SUNDRY NOTICES AND REPORTS ON WELLS

Plugging Procedure Farrell Federal #16 API - 30-041-10433 Sec. 28, T7S, R33E, UL-A 660' FNL 660' FFL

Farrell Federal 16 30-041-10434 Ridgeway Arizona Oil Corp November 21, 2017 Conditions of Approval

Co. Rep	0	
Well Name	Farrell Federal	Well No. 16
Field	Chaveroo San Andres	_
County	Roosevelt	
State	NM	_
Date		_
Date Comp		_
KB	4411 RDB	-

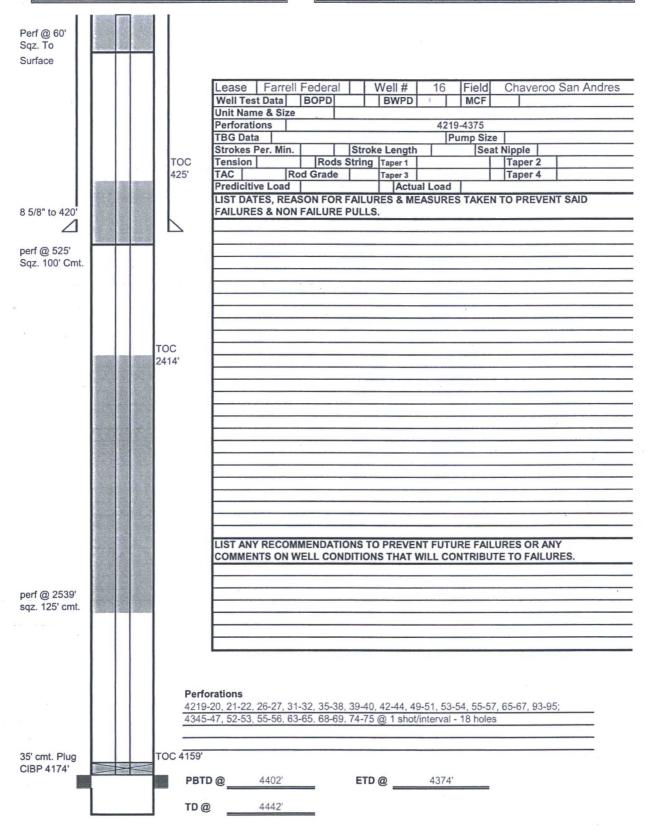
- Notify OCD/BLM 24 hours prior to commencement of P&A procedures
 NDWH/NU BOP
 RIH w/ 4 ½" CIBP on 2 3/8" workstring @ 4174' (+/-)- within 50' if top perf 4219'
 - a. Spot 35' of cement on CIBP
 - b. WOC bump plug @ 4139' (+/-)
- 6. Load well with a minimum of 9 lb. mud and conduct MIT to 500 psi., test for leak off
 - a. Bleed pressure off after MIT
- 7. MIRU WL and RIH w/ perf gun to 2539'
 - a. Perforate @ 2 JSPF
 - b. POOH w/WL
 - c. RDWL
- 200 (to sent the top of the Yates)

** pung added to sent the

50' above + below the shoe

- 1. Operator shall place CIBP at 4,169' (50'-100' above top most perf) and place 35' of Class C cement on top as proposed. WOC and TAG.
- 2. Operator shall perf and squeeze at 2,539'. Operator shall place a balanced Class C cement plug from 2,539'-2,200' to seal the top of the Yates formation. WOC and TAG.
- 3. Operator shall place a Class C cement plug from 1,900'-1,700' to seal the salt.
- 4. Operator shall perf and squeeze at 525' as proposed tagging plug at 370' to seal the surface shoe. WOC and TAG.
- 5. Operator shall shall perf and squeeze at 60' brining cement to surface.
- 6. See Attached for general plugging stipulations.
